73A NEW TOWN ROAD NEW TOWN TAS 7008

Three storey development comprising multiple dwellings. Refer to attached supporting documentation.

<b>Council Planning Permit No.</b>	PLN-22-282	<b>Council notice date</b>	5/09/2022
<b>TasWater details</b>			
<b>TasWater Reference No.</b>	TWDA 2022/00684-HCC	<b>Date of response</b>	27/10/2022
<b>TasWater Contact</b>	Anthony Cengia	<b>Phone No.</b>	0474 933 293
<b>Response issued to</b>			
<b>Council name</b>	CITY OF HOBART		
<b>Contact details</b>	coh@hobartcity.com.au		
<b>Development details</b>			
<b>Address</b>	73A NEW TOWN RD, NEW TOWN	<b>Property ID (PID)</b>	5515409
<b>Description of development</b>	Demolition, 22 Multiple Dwellings, Front Fencing, and Associated Works		
<b>Schedule of drawings/documents</b>			
<b>Prepared by</b>	<b>Drawing/document No.</b>	<b>Revision No.</b>	<b>Date of Issue</b>
Philp Lighton	092.21144 Sheets DA02, DA10, DA11, DA12, DA14, DA15	C	17/10/2022
Philp Lighton	092.21144 Sheets DA09, DA15, DA16, DA17	B	17/10/2022
Rare	220008 Sheets C501, C601	3	11/10/2022
Rare	220008 Sheet C701	4	11/10/2022

NEW TOWN ROAD STREET MONTAGE

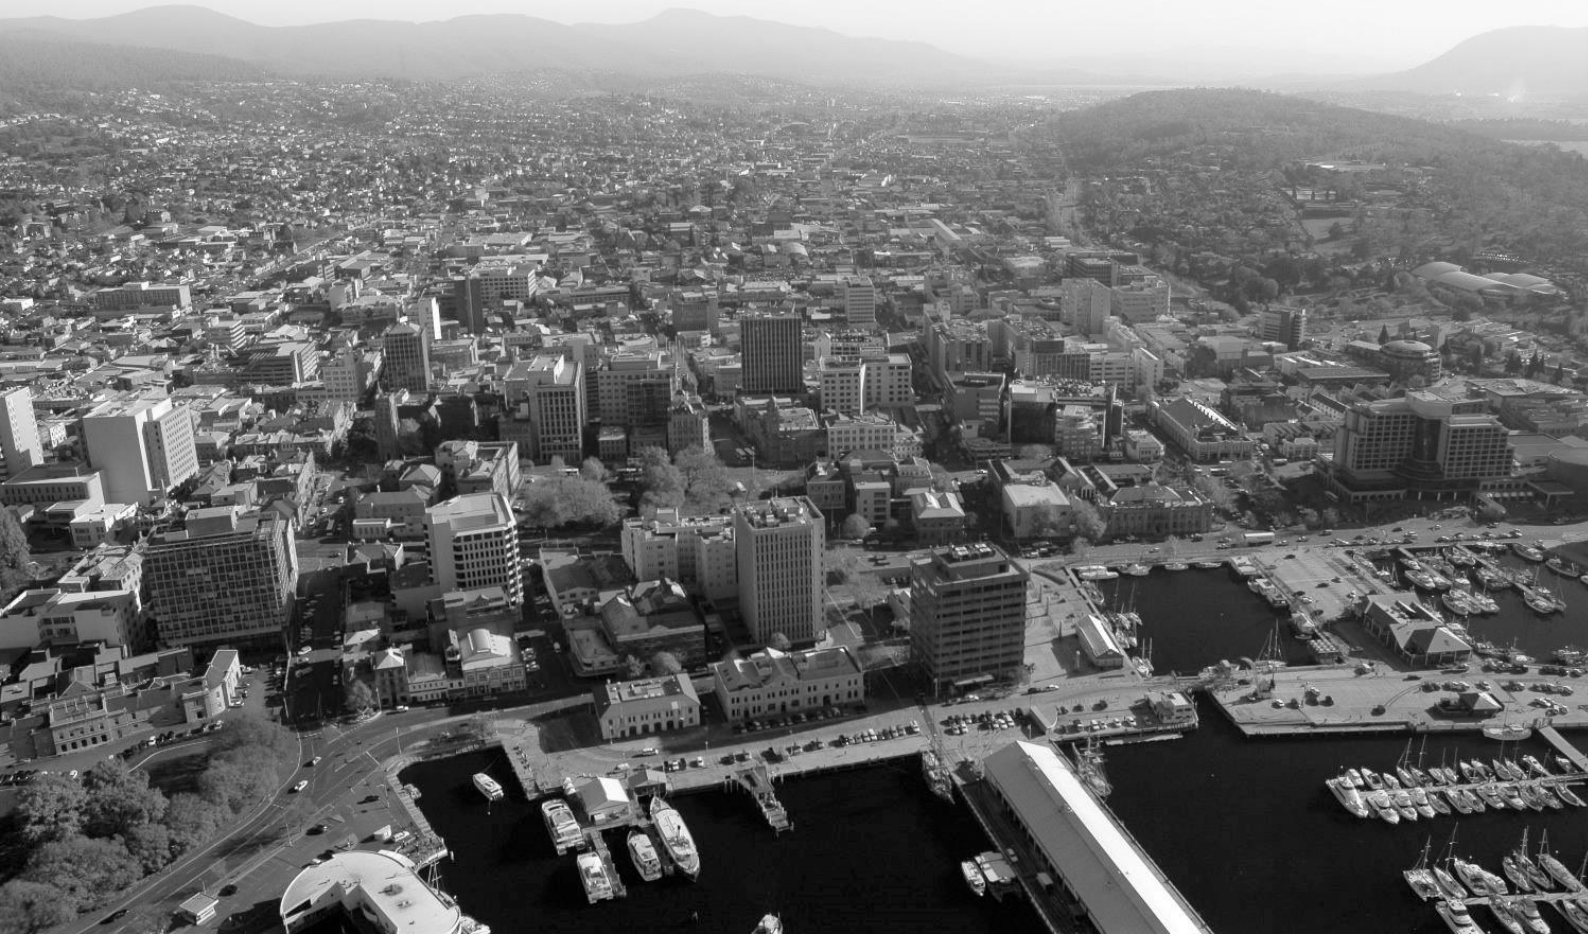
2	Details on lighting and security of bicycle parking area.	<p>Bicycle parking is provided in the form of three hoop racks under the stairs. They are not visible from the streets, and bikes can be securely attached to the hoops. Lighting is provided over the bike racks in accordance with Table 2.3 of <i>Australian/New Zealand Standard AS/NZS 1158.3.1: 2005 Lighting for roads and public spaces – Pedestrian area (Category P) lighting – Performance and design requirements</i>.</p> <p>Refer to Sheet DA90 of the architectural plans prepared by PhilpLighton Architects.</p>
<b>Heritage Code</b>		
HER Fi	To enable the Council to assess the application against the relevant provisions of the Historic Heritage Code of the <i>Hobart Interim Planning Scheme 2015</i> please provide:	
1	Please provide montages of the proposal as viewed from the streetscape of New Town Road.	<p>A streetscape montage is provided from ‘eye level’ directly across the street on New Town Road.</p> <p>Refer to Sheet DA93 of the architectural plans prepared by PhilpLighton Architects.</p>
